COUNCL RECOMMENDATION FOR DA863/2016 (2016SYW082 DA)

PROPOSED RESIDENTIAL FLAT BUILDING 2-2A Hepburn Ave + 199-203 Carlingford Rd Carlingford

1.1 I provide this expert opinion, relating to **solar access** and **cross ventilation** compliance for the proposed residential flat building at 2-2A Hepburn Ave + 199-203 Carlingford Rd Carlingford.

This report is an independent review of the architects' compliance reporting included with the development application DA863/2016 of 20 April this year, and responds to the relevant portions of Council's report of 7 June 2017.

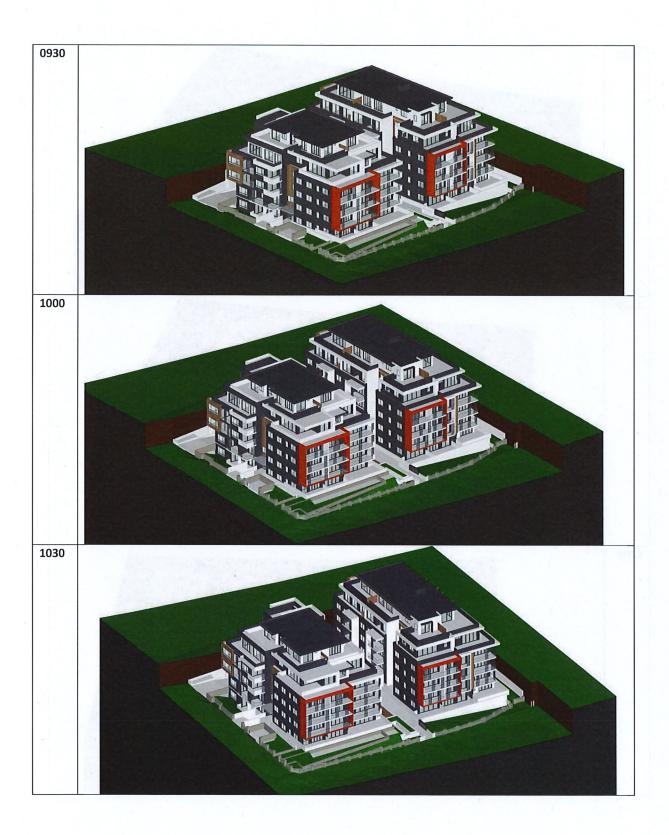
The table below shows the detailed solar access and cross ventilation compliance status of each unit.
